SERVICE INFORMATION

No. : SI-V47075-G

Date: Jan. 18, 1993

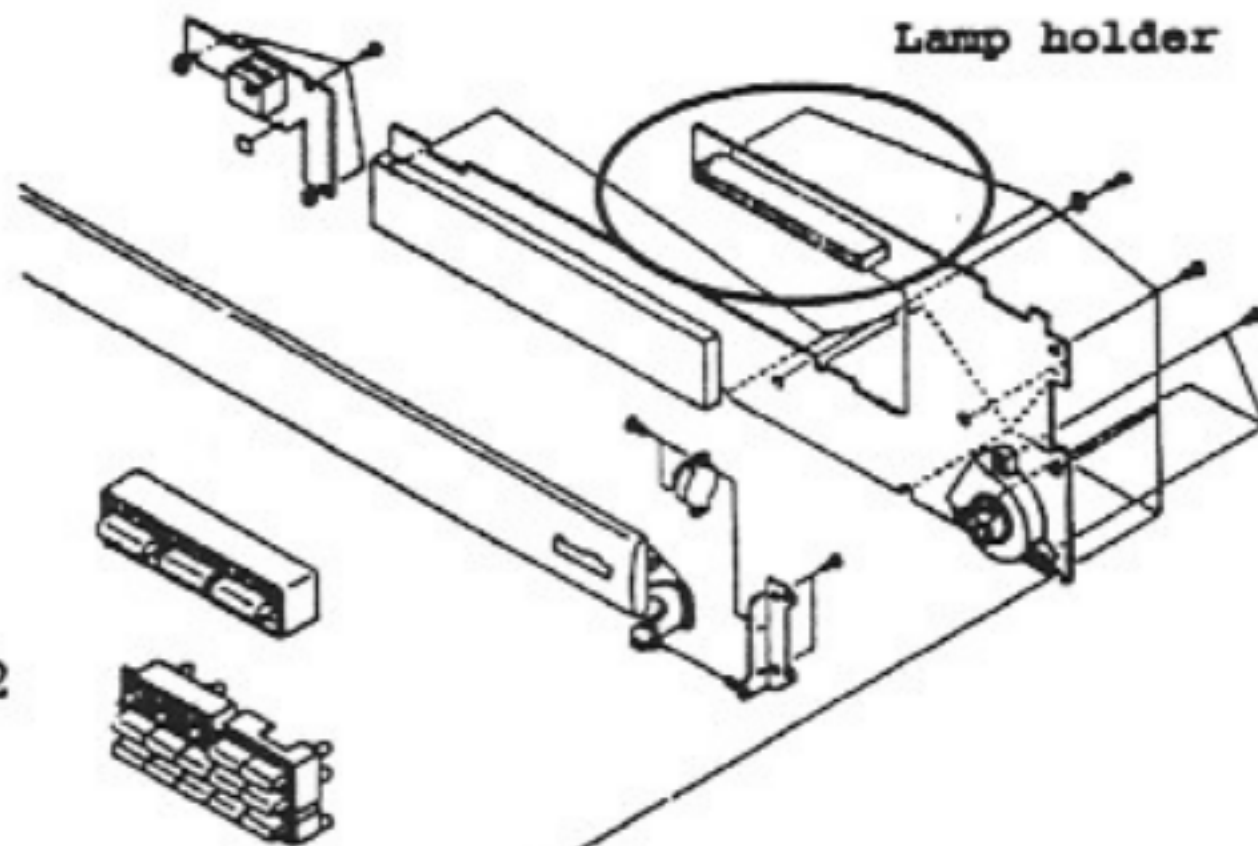
MODEL NO.	* SER. NO.	MODEL NO.	* SER. NO.	MODEL NO.	* SER. NO.
CLD-3090/KU/CA	A ---	CLD-2290/RD	A ---	CLD-2700/WB	A 7503201 -
CLD-2090/KU/CA	A ---	CLD-2600/WB	A ---	CLD-2700/WEZ	A MJ7407201 -
CLD-3390/RD	A ---	CLD-2600/WEZ	A ---		
# DETAIL OF CHANGE(S)			REASON FOR CHANGES		
1	Change of a lamp holder in FLKY ass'y		X	To prevent the lamp holder for the Disc side indication from being deformed due to heat

<problem> Disc side won't be changed with the DISC SIDE buttons pushed.

<CAUSE> The lamp holder for Disc side indication gets deformed by heat when the ambient temperature is high. So, the Disc side button can't push the switch properly.

Deformed by heat.

<COUNTERMEASURE IN FACTORY>

Changed the material for the lamp holder.

Lamp holder: N.S.P. ---> VNL1532

When you encounter the above problem, please replace the lamp holder with the new part (VNL1532).
